### APPEAL SUMMARY

<b>Appeal ID:</b> 22148	<b>Project Address:</b> 3181 SW Sam Jackson Park Rd
<b>Hearing Date:</b> 11/20/19	<b>Appellant Name:</b> Kerry Hegedus
<b>Case No.:</b> B-012	<b>Appellant Phone:</b> 206.223.5180
<b>Appeal Type:</b> Building	<b>Plans Examiner/Inspector:</b>
<b>Project Type:</b> commercial	<b>Stories:</b> 14 <b>Occupancy:</b> I-2, B, A-3, S-2 <b>Construction Type:</b> 1-A
<b>Building/Business Name:</b> OHSU	<b>Fire Sprinklers:</b> Yes - everywhere
<b>Appeal Involves:</b> Erection of a new structure	<b>LUR or Permit Application No.:</b>
<b>Plan Submitted Option:</b> pdf [File 1]	<b>Proposed use:</b> hospital

PER 2018 IFC CODE & COMMENTARY

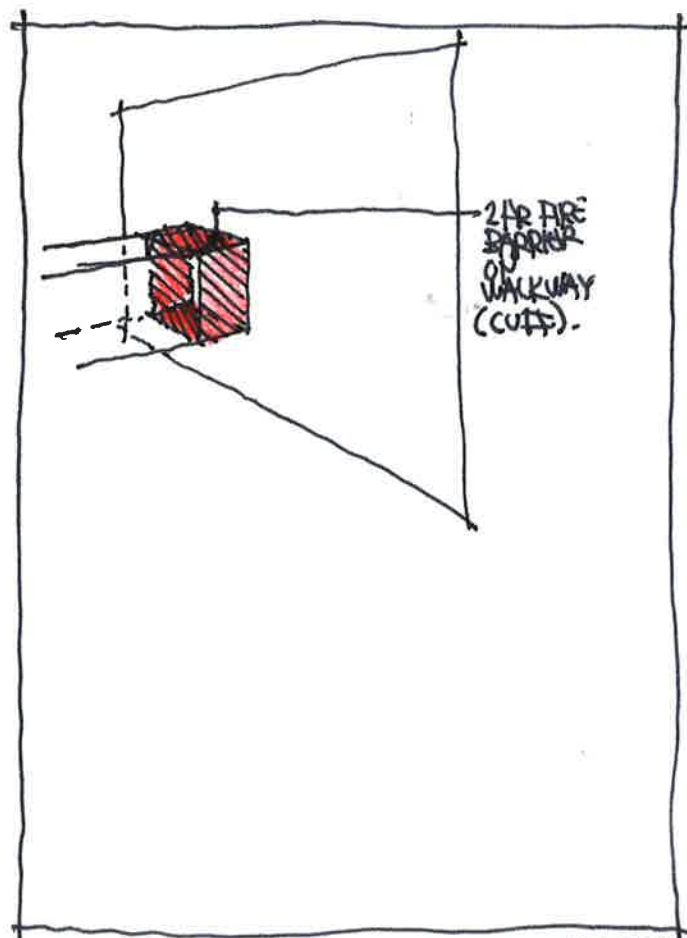
**Proposed Design** the new pedestrian walkways are proposed to have the 2-hour fire resistance rated construction on all sides of the walkway to create a rated "cuff" on the walkway, rather than the rated "collar" on the buildings that the walkway connect to (as illustrated in the code commentary). the rating on the walkway still provides the same fire separation (rating and distance), it just moves the location of separation onto the walkway.

and provides better protection of occupants (if in the adjacent building). see the attached diagrams illustrating the current commentary diagram vs. the proposed. the walkways have two access points and exits, so that still remains the same.

**Alternate 2 hour protection of pedestrian walkway: Hold for additional information.**
